# Northern LTMA Region Airspace Change (OFJES, CLN CTA11/12, FL105+)

Gateway Documentation:  
Stage 2 Develop and Assess  
Engagement Evidence  
ACP-2025-023

## 2. Engagement Material (8<sup>th</sup> May 2025)

### 3. Meeting minutes (8<sup>th</sup> May 2025)

## Proposal seeking feedback

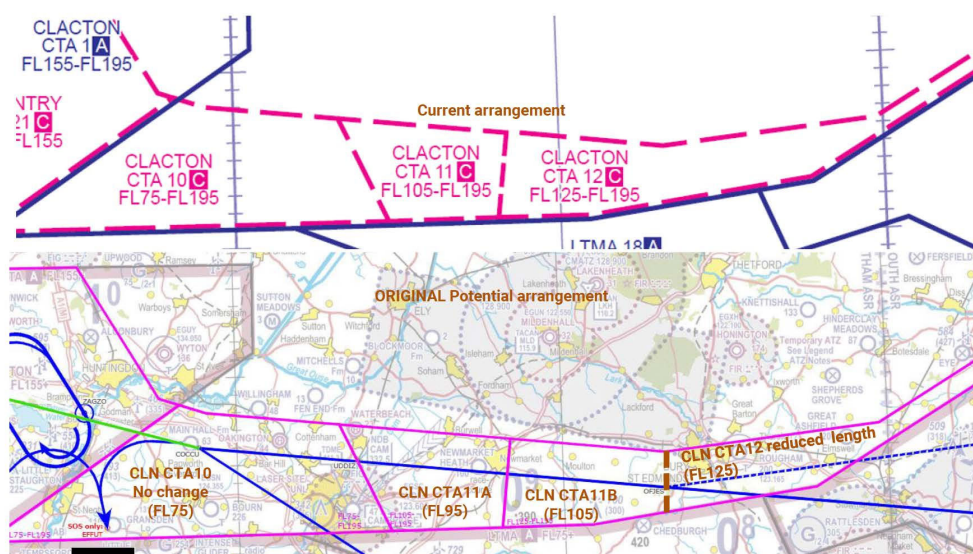
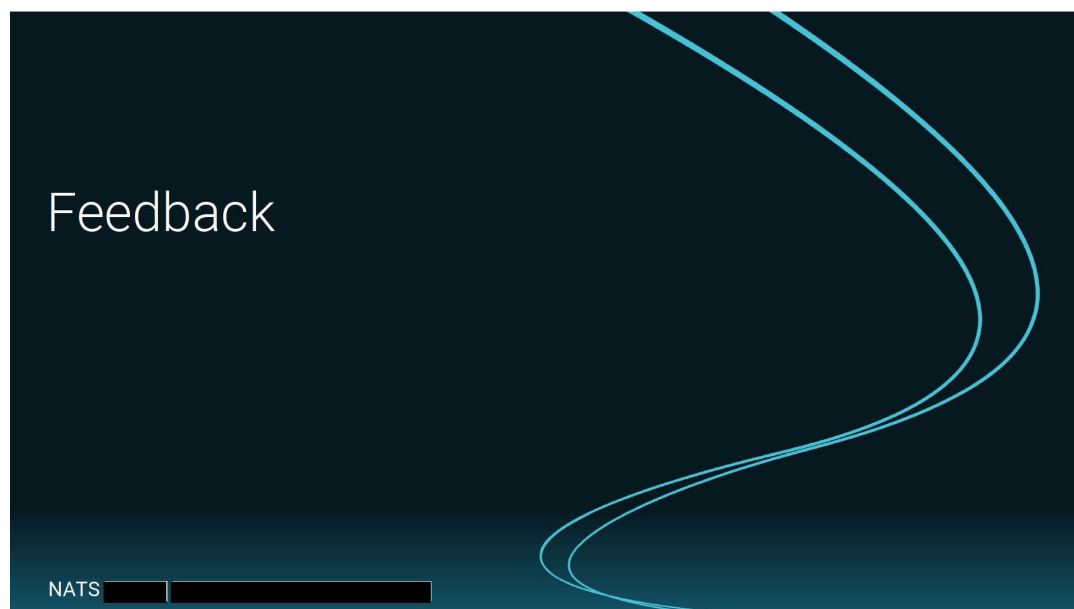
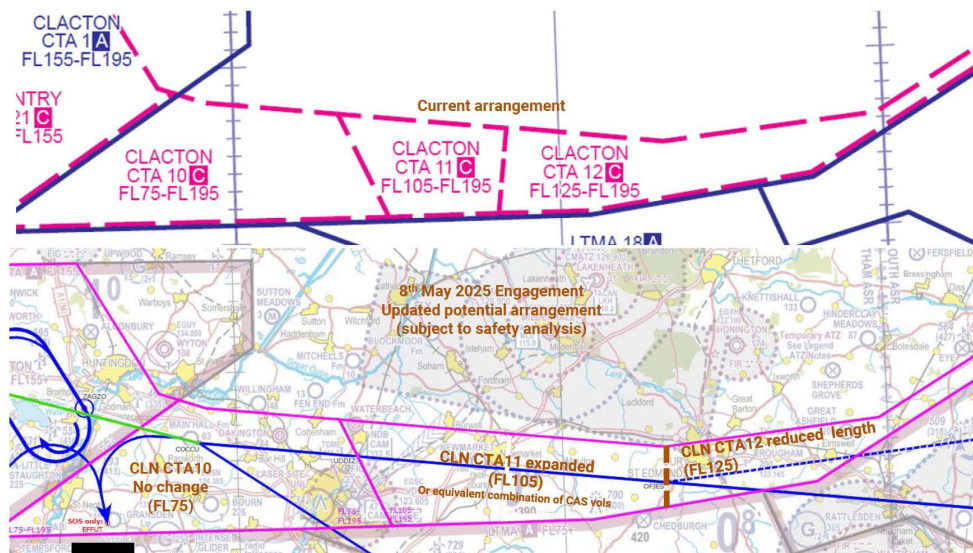
discussed the RAPCON operation and CAS options. The consensus was that dropping the base of CTA11 to FL95, as originally-considered, would likely cause significant adverse impacts on RAPCON, especially under easterly PFO exercises. Expanding the FL105 base of CTA11 eastwards, with a corresponding reduction in CLN CTA12, may cause impacts of a less significant nature, in effect reducing RAPCON's "headroom" when operating above high-flying General Aviation such as gliders, but with less impact on PFO and other ops.

A further brief discussion took place re vertical vs lateral and weekend-limited options, confirmed these would not provide effective mitigation against the identified risk due to the density/timing of Luton arrivals. Some discussion considered the use of different classifications of airspace such as Class E which, while technically CAS, has no entry condition if operating VFR. For Class E, RAPCON's status could be "Enhanced ATSU" (likewise if Class D). We noted that FL100+ is TMZ therefore no specific TMZ would be required for a CAS base FL105.

From this, we understand that our FL95 CAS base design option is not acceptable to MoD/USAFE due to the significant adverse impacts it would have on USAFE Practice Flame-Out (PFO) exercises when RAPCON is using the easterly Lakenheath runway.

We also understand that the alternate design we showed, CAS base FL105, would be far less impactful, and would in principle be acceptable to the MoD/USAFE for further development.

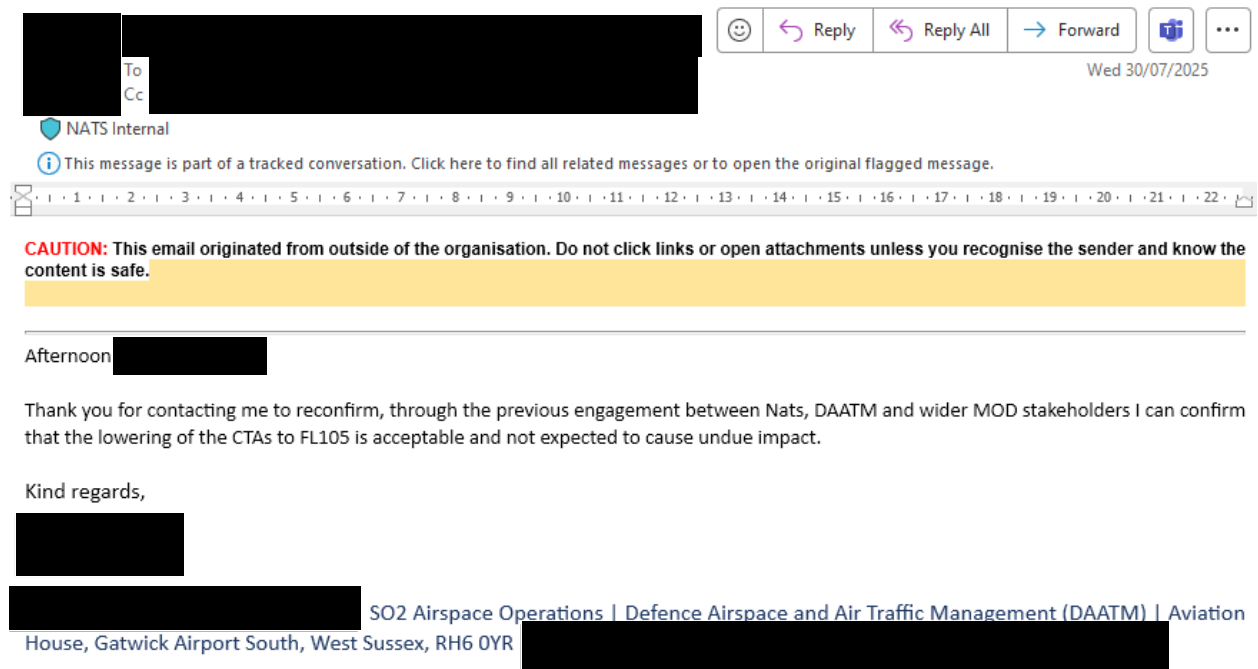
One paragraph of the minutes from that meeting was:  
*The consensus was that dropping the base of CTA11 to FL95, as originally-considered, would likely cause significant adverse impacts on RAPCON, especially under easterly PFO exercises. Expanding the FL105 base of CTA11 eastwards, with a corresponding reduction in CLN CTA12, may cause impacts of a less significant nature, in effect reducing RAPCON's "headroom" when operating above high-flying General Aviation such as gliders, but with less impact on PFO and other ops*
